WORK ORDER NON-CONFORMANCE / UPDATE

Item ID: 646.3811 Accept ***N900040100*** Setup Start ***NS1***
 Revision ID: Stop ***NS2***
 Item Name: Radius Block
 Start Date: 5/30/2017 Start Qty: 10.00 ***10*** Cust Item ID:
 Required Date: 6/20/2017 Req'd Qty: 10.00 ***10*** Customer:
 Reference:

APICAL INDUSTRIES, INC.	ENGINEERING CHANGE NOTICE NO. 03697				SHEET 1 OF 1	
	DWG NO. 646.3800	REV: N/C	PREPARED BY B. PETERS	DATE: 11/14/12	EFFECT ON DWG ☐ INC. ☒ UNINC.	
	DWG TITLE: BRACKETS					
	APPROVED BY: ENGR <i>[Signature]</i>	MFG <i>David Baker</i>	QC <i>[Signature]</i>	EFF: NEXT ORDER		
TRANSACTION CODES (TC) A-ADD C-CREATE R-REVISE D-DELETE	REASON: ADDED ALTERNATE MATERIAL.				ECR: D-12-006

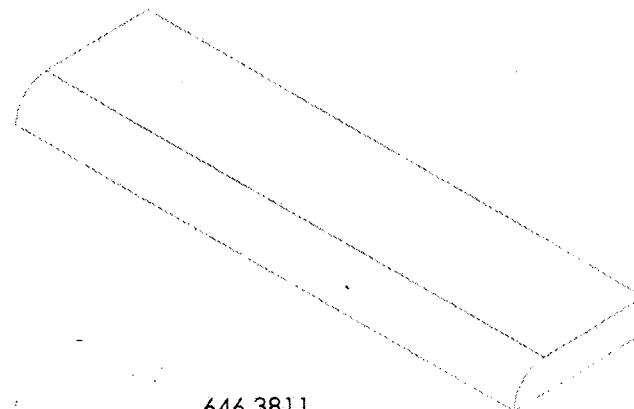
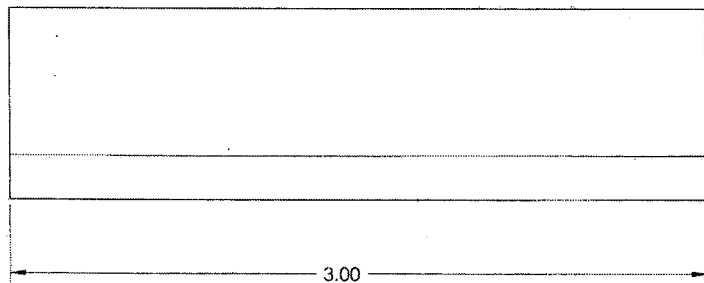
SHEET 1, ZONE A2 IS:

⚠ PRIMARY MATERIAL: 7075-T651 ALUMINUM PER AMS-QQ-A-250/12.
ALTERNATE MATERIAL: 7075-T6511 ALUMINUM PER AMS-QQ-A-200/11.
